Approvals for Outdoor Dining on Public Streets

1. The Hammer – 49 Pleasant St.

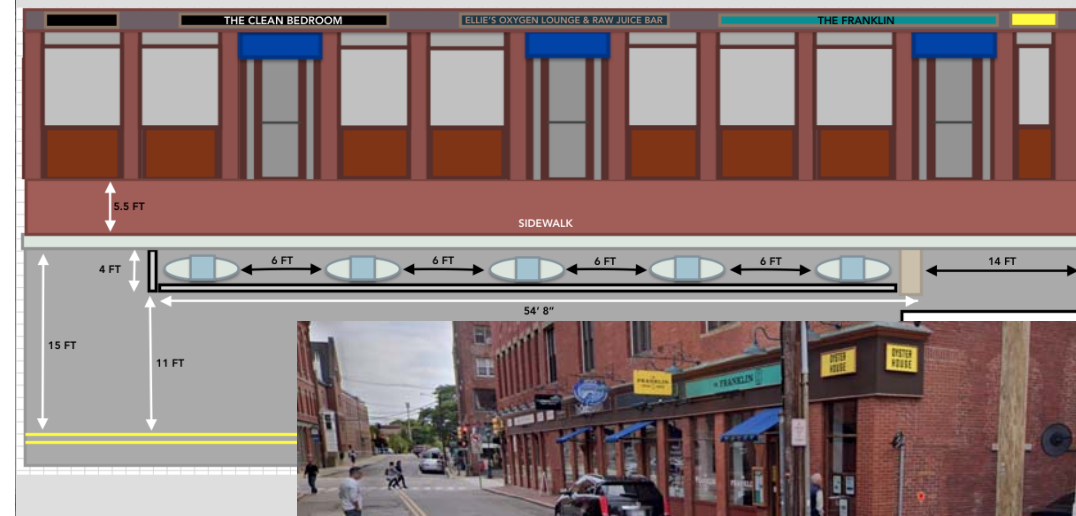
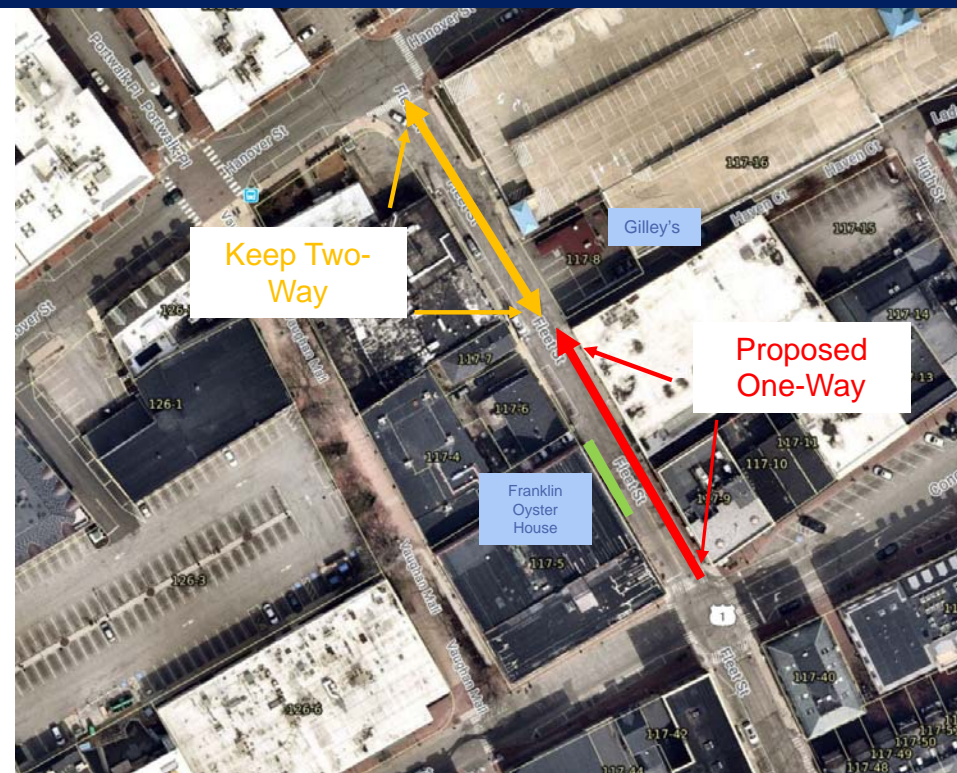
Originally approved for use of loading zone on State Street and two parking spaces on Pleasant Street. Revised request proposes use of loading zone plus one parking space on State Street.

RECOMMEND APPROVAL IS CONTINGENT ON:

- Use of loading zone and one parking space on State Street;
- Vehicular access to driveway to be maintained at all times;
- Staff approval of tables/seating diagram.

2. Franklin Oyster House – Fleet St.

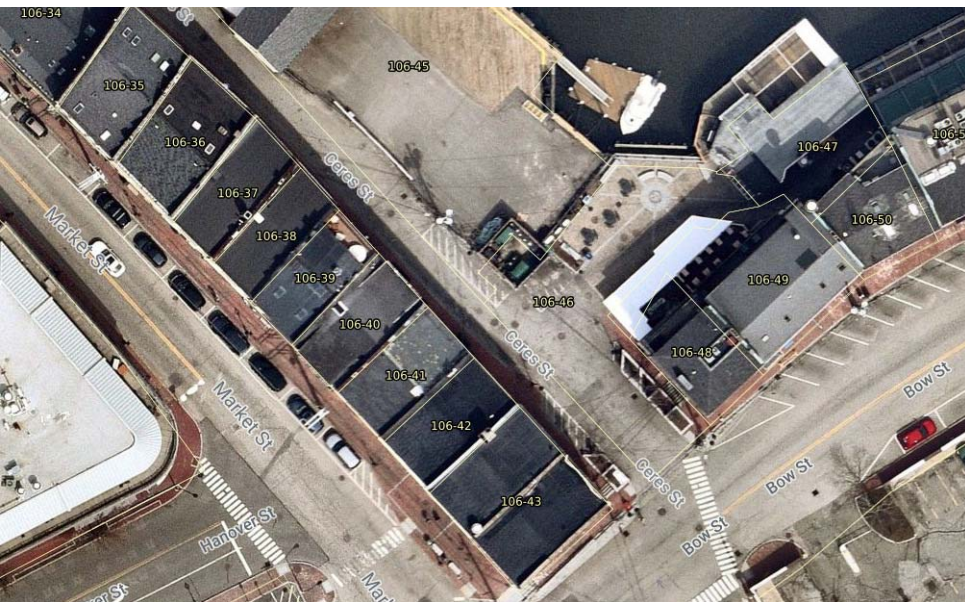
RECOMMEND APPROVAL IS CONTINGENT ON:

- Conversion of Fleet Street to one-way traffic only from Congress Street to edge of Gilley's parking lot;
- Approval from abutting property owners for use of street frontage;
- Staff approval of tables/seating diagram.
